From: Mark Simmons <Mark.Simmons@north-herts.gov.uk>
Sent: 06 December 2024 13:06:54 UTC+00:00
To: "Andrew Hunter" <Andrew.Hunter@north-herts.gov.uk>
Subject: 5no. DOC's re: Bibbsworth Hall Farm, Bibbs Hall Lane, Kimpton
Importance: High

- **24/02482/DOC**- Details reserved by condition 2 (Roof Repairs) of listed building consent 22/02290/LBC granted 14.11.2022
- **24/02554/DOC**- Details reserved by condition 4 (Repointing South-West Corner Brickwork) of listed building consent 22/02290/LBC granted 14.11.2022

Figure 9 (bottom): Solid wall – Internal insulation with timber battens

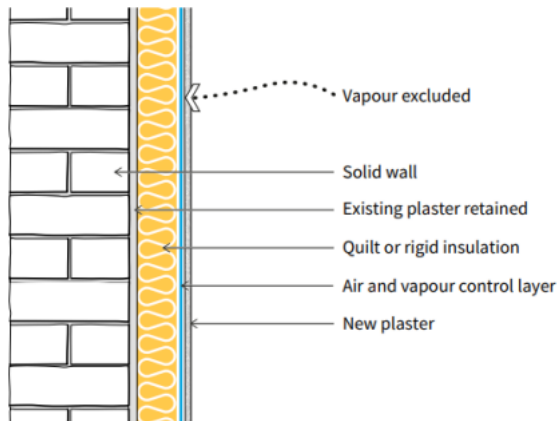
Response: What is of interest here is that in the red highlighted text above, an insulation strategy was put forward based on a wood fibre insulation and lime plaster approach, in areas where there are no historical cornices or skirting board. It is stated that where original detailing exists, it may limit the thickness of insulation that can be applied. Furthermore, it says that differing solutions will be applicable in different areas of the structure and that **there is no blanket approach**. However, a blanket approach is proposed and that this also does not appear to be either i) a wood fibre system or ii) a lime hemp system. The Fig 9 Historic England example does not distinguish between quilt or rigid insulation or whether the new plaster is lime-based or standard gypsum/carlite. It is unclear as to how advanced the works are on site, even if the insulation system has already been applied, more clarification is needed with respect to the impact on any cornice/skirting/window reveal/door architrave details and whether an assessment has been undertaken as to whether different solutions are applicable to different parts of the building as previously noted.
